Consultation title: Mobile Communications onboard Aircraft

Representing (self or organisation/s): Orange UK

Orange response to Ofcom consultation 'Mobile Communications onboard Aircraft' (November 2007)

Fig 1
Gain(dB)

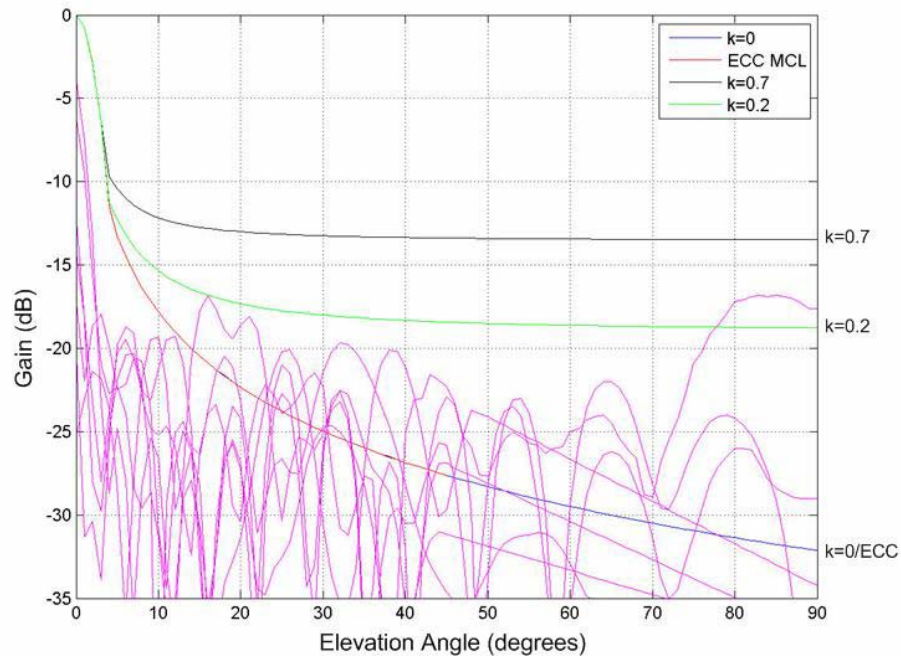
ECC Report 93 significantly over estimates terrestrial network antenna side lobe roll off performance (referenced from ITU Rec. F-1336-1). Orange has considered the patterns of a selection of antennas used in its network Fig.1 and found that the report under estimates side lobe gain by up to 15dB at elevations between 10 and 90 degrees.

ECC Report 93 uses a pattern conforming to $k=0$ for minimum coupling loss calculations. (ITU Recommendation F-1336-2 patterns $k=0.2$ & $k=0.7$ are displayed for reference). Orange believes a revised pattern which is representative of the worst case side lobe performance of deployed network antennas is necessary to avoid significant underestimation of side lobe gain. Orange suggests that the minimum coupling loss analysis and associated SEAMCAT analysis should be re-run using more realistic antenna patterns to assess the impact on the conclusions of the report.
